Technical Memorandum

Pages: 12
Ref: 17-000934.3015TM03.AM.rl

Subject: AURA Precinct 11 to 14 – Further Issues (3 Dec 2020) Response

This Technical Memorandum is to provide additional information following the EDQ Further Issues letter dated 3 December 2020 and Lot Layout Changes Request dated 30 November 2020.

ACOUSTIC TREATMENT
PLAN SHEET 2 OF 3

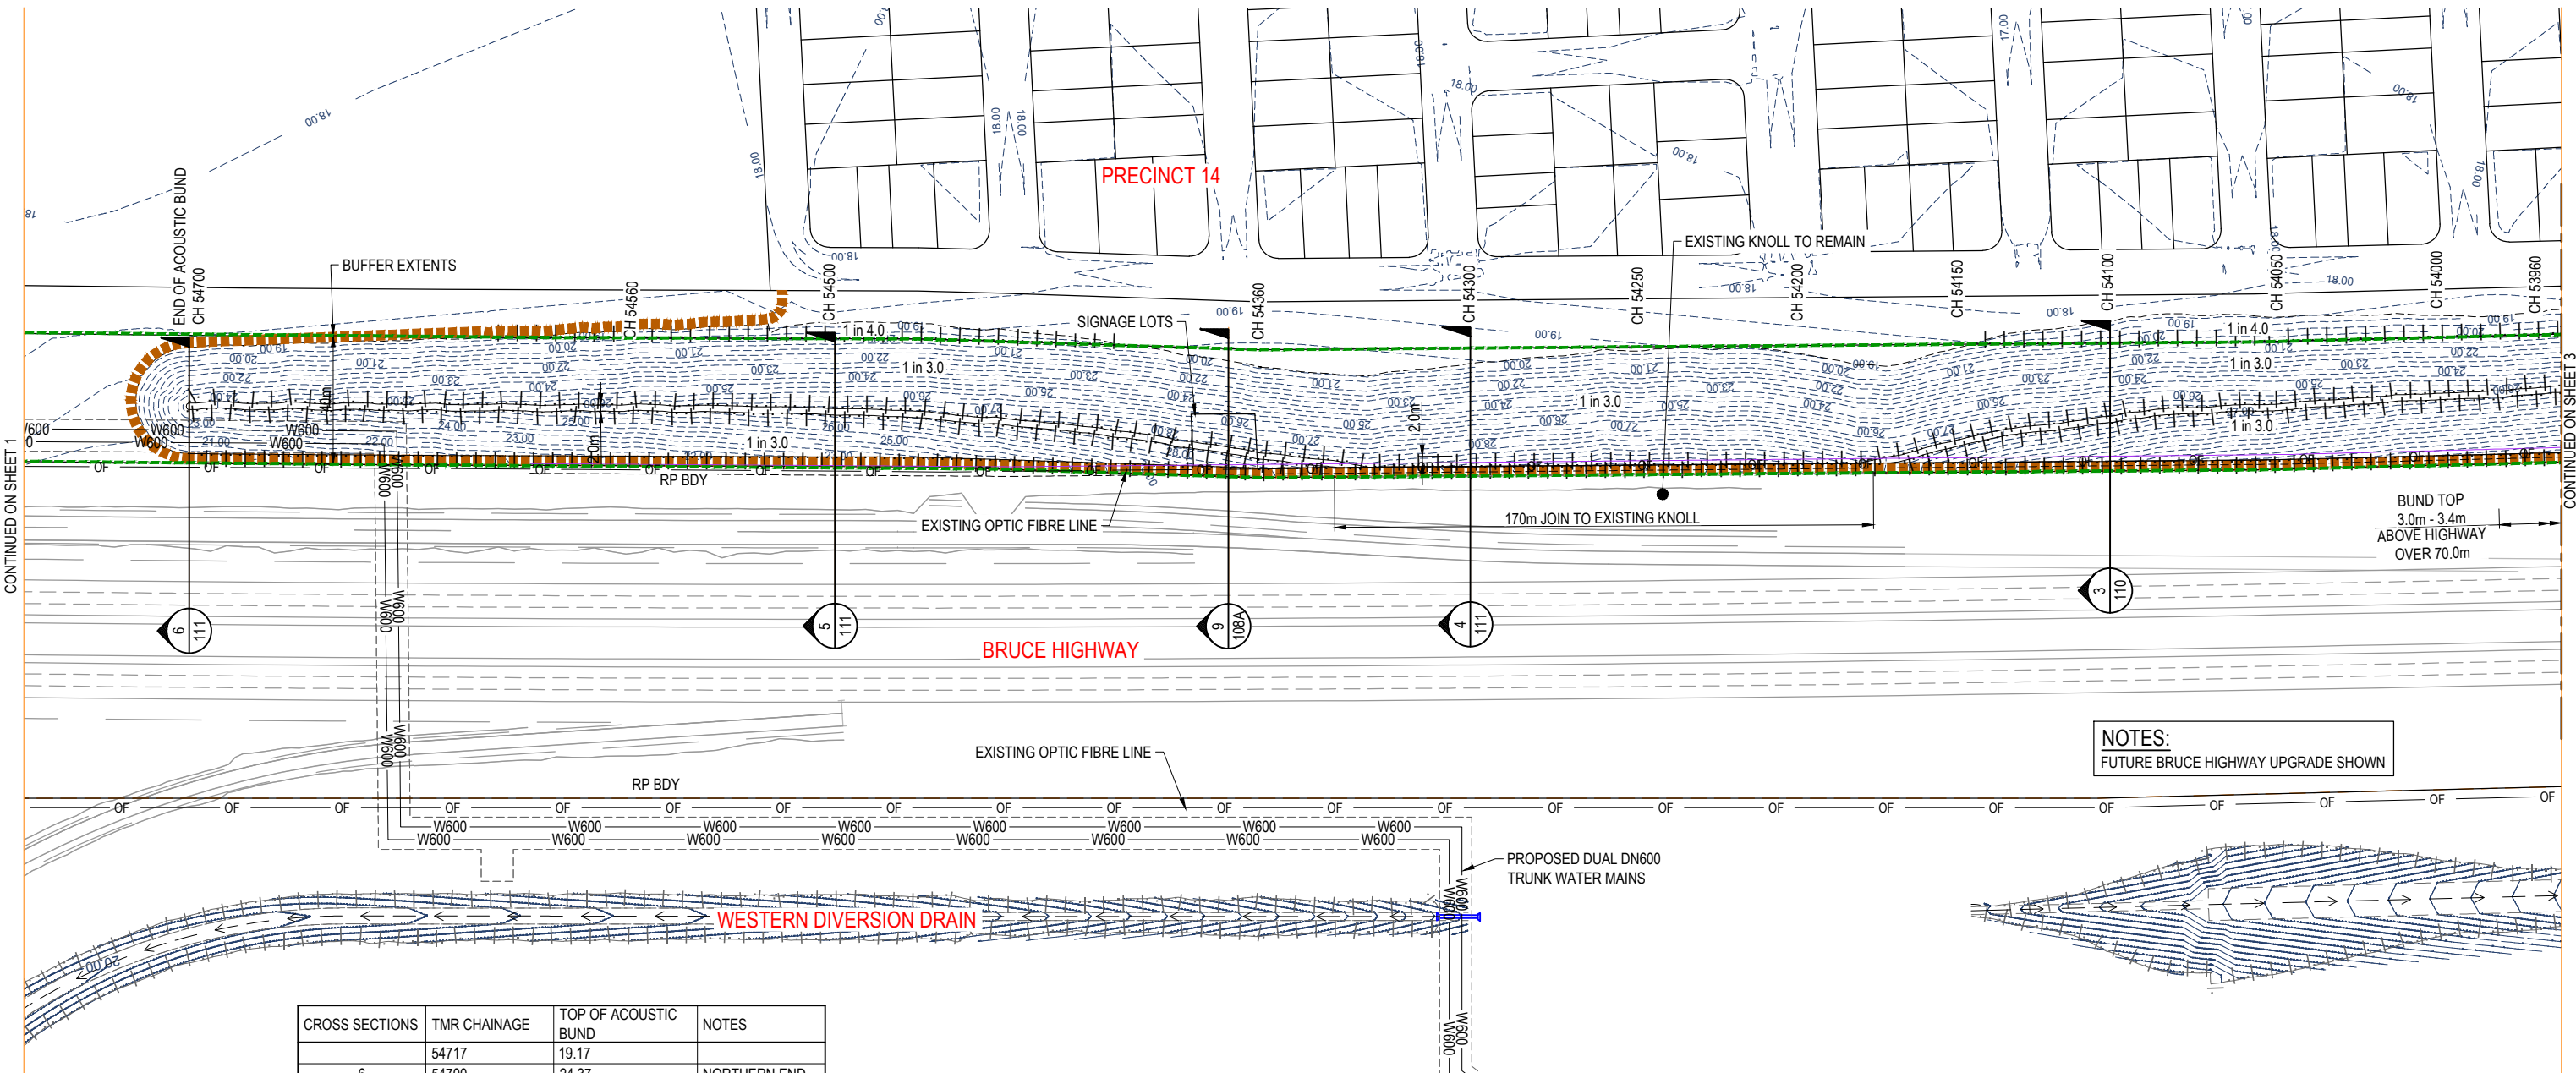
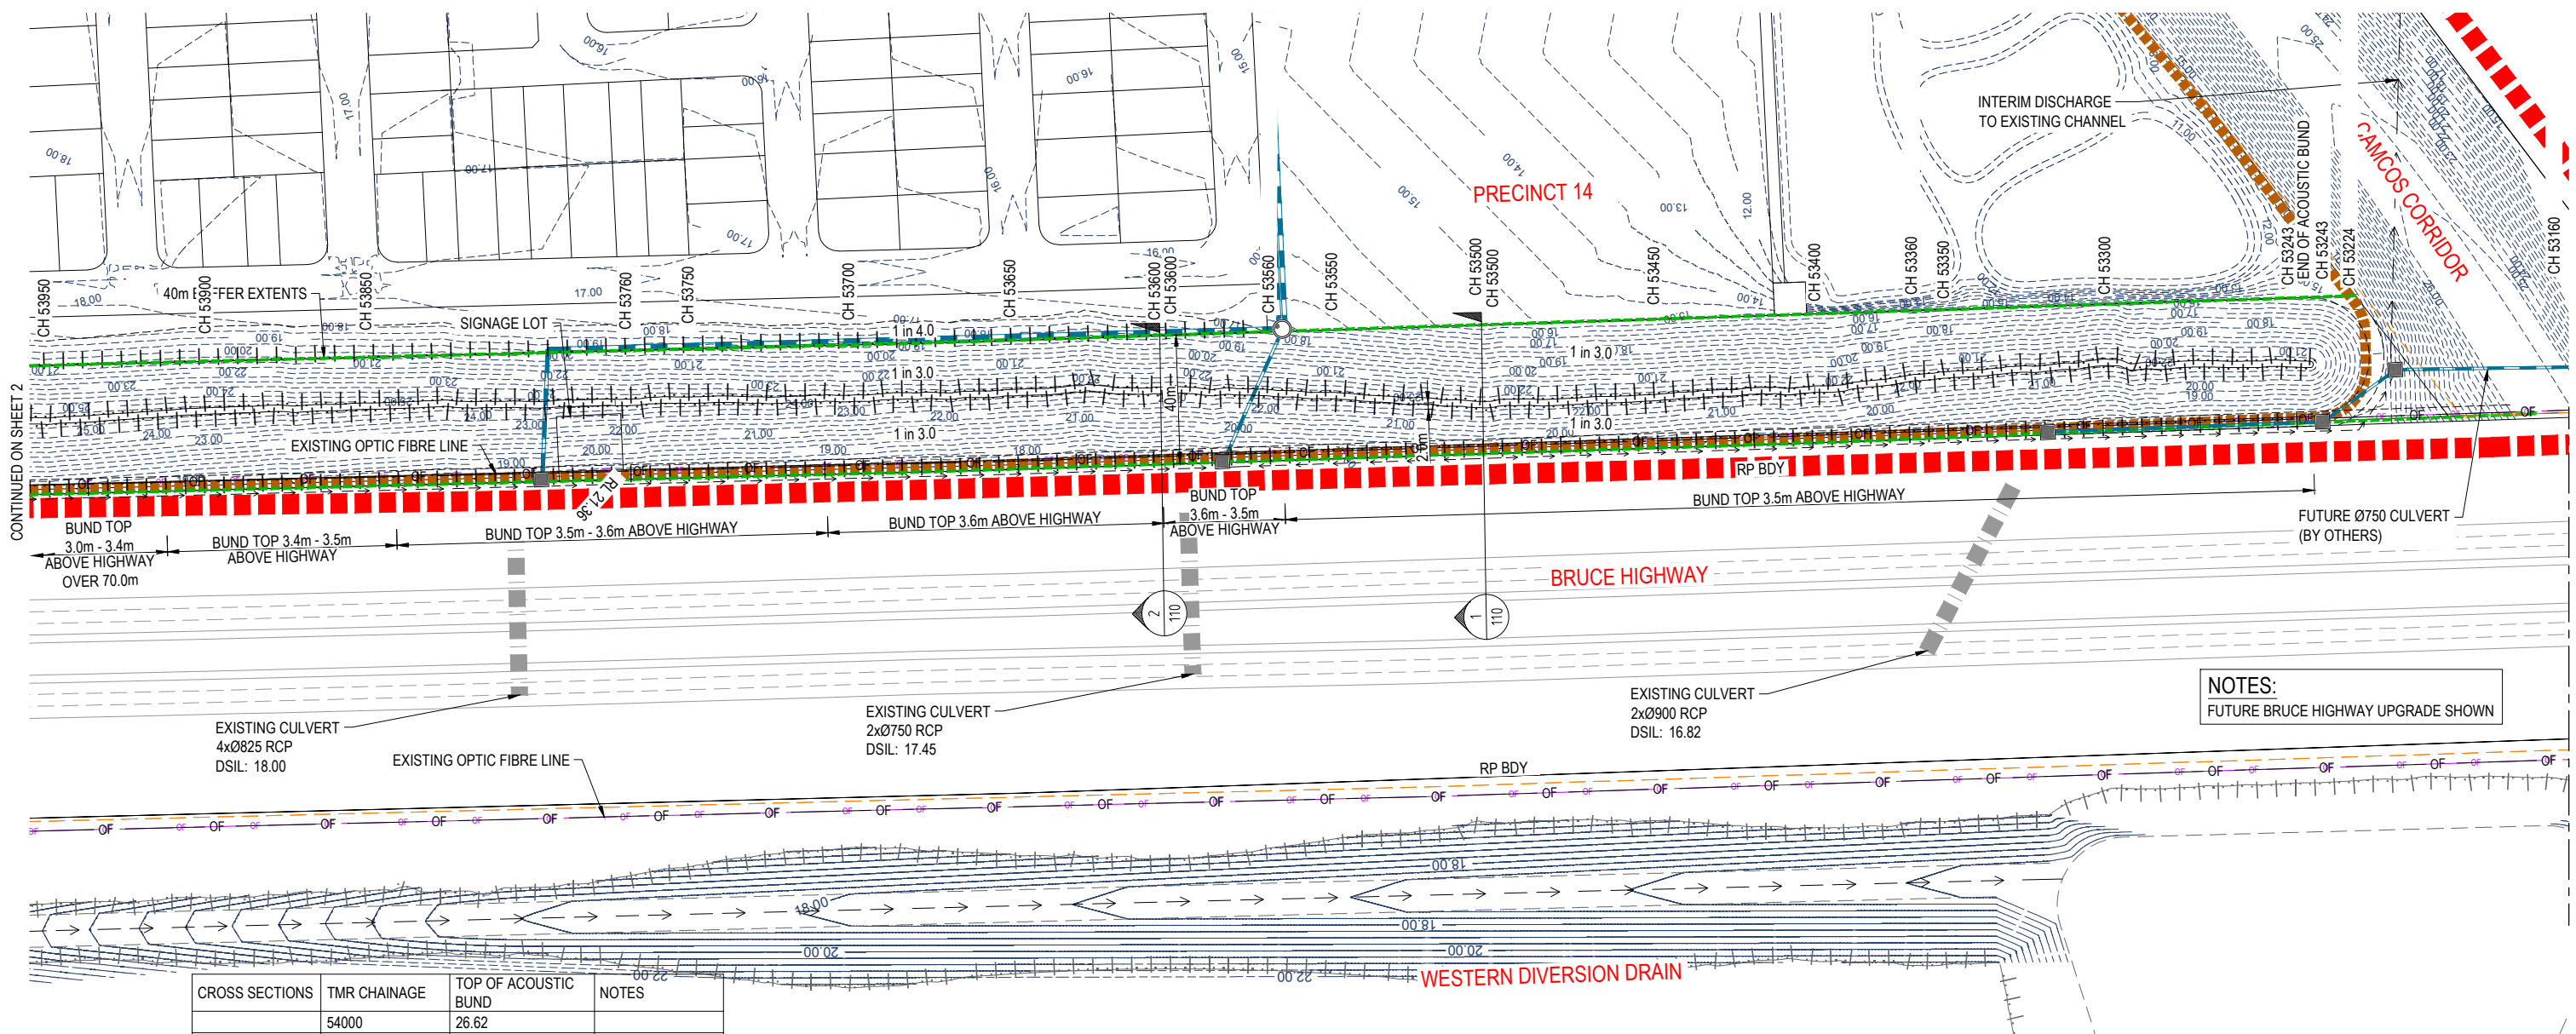
7. Clarify the figure of the proposed earth mound along the Bruce Highway which performs as a noise barrier as the levels in the drawings are difficult to read. For clarity, this figure shall be clearly annotated with the top edge reduced level (RLs) of the earthbound every 10m along the mound, any change in mound height and at the mound ends.

Refer to Calibre Sketch plan 17-000934.3015 sheets SK108 Rev E & SK109 Rev F (attached) which indicate the proposed acoustic bund in accordance with ASK Consulting Acoustic Reporting July 2020. Additional top of bund levels has been added at 50m intervals and at critical top of embankment grade changes to assist with clarity. Given the bund is approximately 1.5km long provision of levels at 10m intervals is significantly finer intervals than are needed to define the top of Acoustic bund and can be considered during detailed design, and as part of the Highway Buffer Plan assessment.

INTERSECTION 85 LAYOUT PLAN
SCALE: 1:500 (A1)
SCALE: 1:1000 (A3)

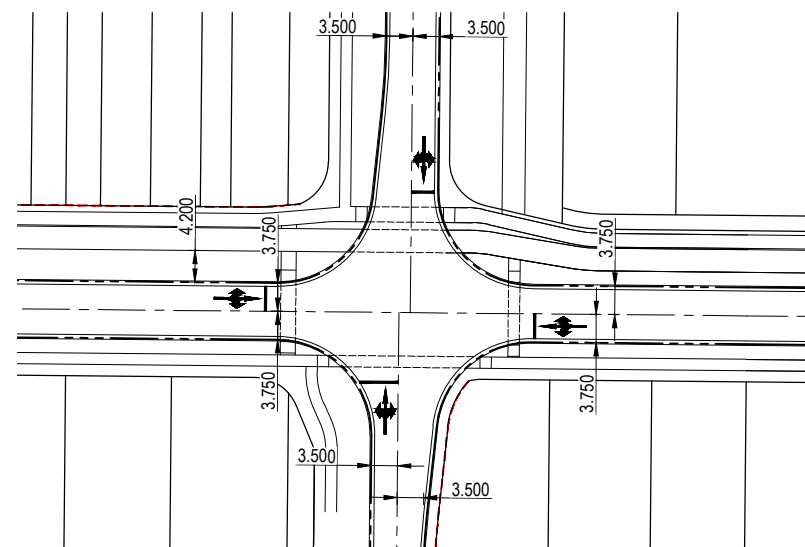
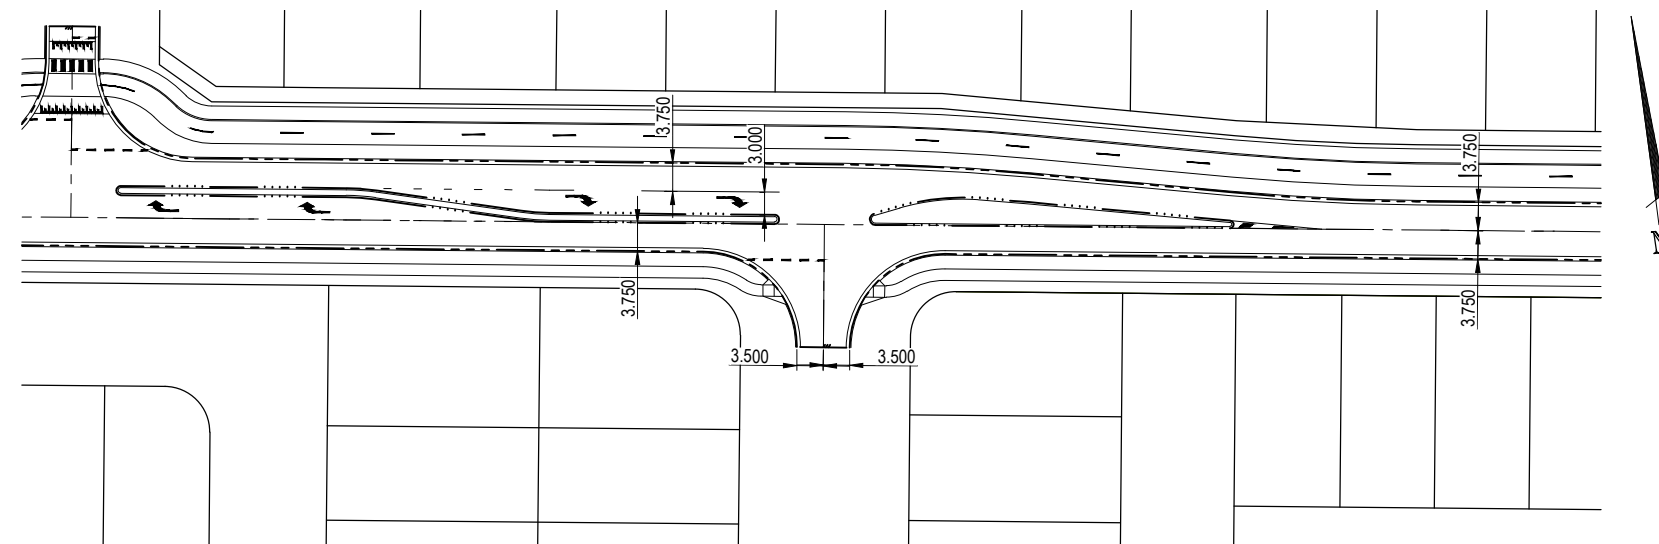
88. Intersection 85 is shown as a signalised intersection on the Road Network Hierarchy in the PWC report but is not designed as such in the Calibre Functional Layout Plan. Amend accordingly.

Calibre Concept design plan **17-000934.3015-DA656** (attached) has been updated as per PWC Refresh P11-14 Traffic Modelling Report to show a signalised intersection.
